Docket Number:	20-FDAS-01
Project Title:	Flexible Demand Appliance Standards
TN #:	240206
Document Title:	ecobee Comments on Flexible Demand Appliance Standards
Description:	N/A
Filer:	Madeline Fleisher
Organization:	ecobee
Submitter Role:	Public
Submission Date:	11/1/2021 5:22:58 PM
Docketed Date:	11/2/2021

ecobee Comments Regarding the California Energy Commission Flexible Demand Appliance Standards

I. Comments Regarding the Pre-Rulemaking Draft of the Proposed Flexible Demand Appliance Standards

Figure 2 - eco+ Time-of-Use Optimization enrollment screen

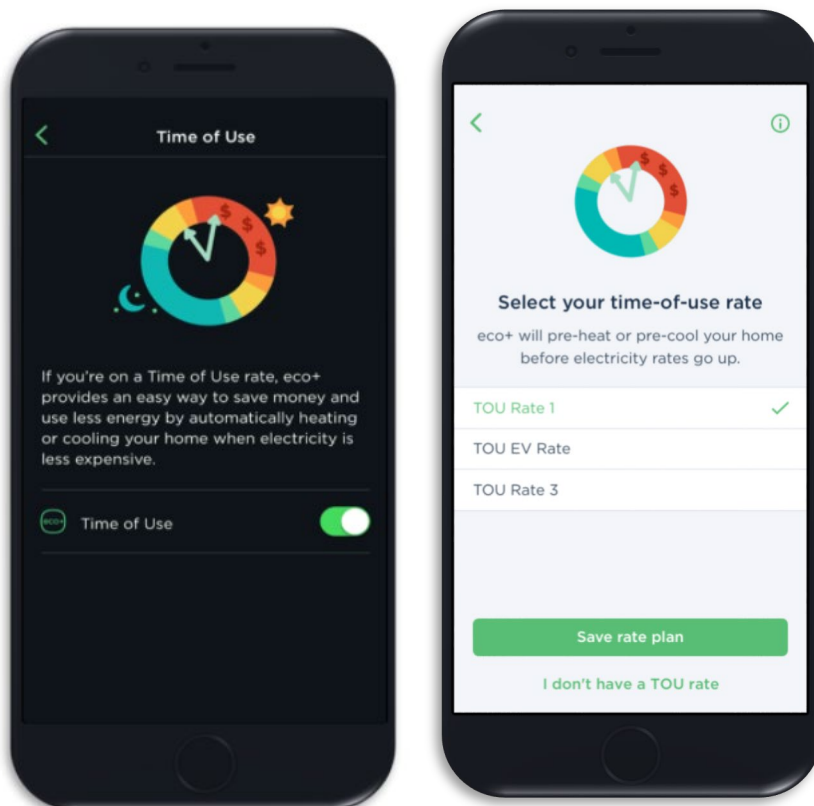
ecobee strongly supports allowing in-app capabilities as through its eco+ platform. The eco+ software upgrade is presented to users through an in-app interstitial. The time-of-use optimization screen is depicted below in Figure 2. Customers are presented with the option of turning on the time-of-use feature by selecting their appropriate rate from a list of eligible TOU rates available to their home address. The customer's rate selection can then be made available to ecobee's utility partners via the ecobee Utility APIs.

This simple process is key to achieving broad consumer uptake. Fundamentally, the less friction for the customer in providing necessary authorizations, the more likely the customer is to choose to participate in providing flexible load resources. Illustrating this point, a 2019 report by the California Public Utility Commission’s Energy Division described an analysis by demand response provider EnergyHub finding that requiring customer provision of utility account numbers significantly decreased demand response (DR) program enrollment as compared to a simpler enrollment process through Smart Meter Texas requiring only the customer name and address:
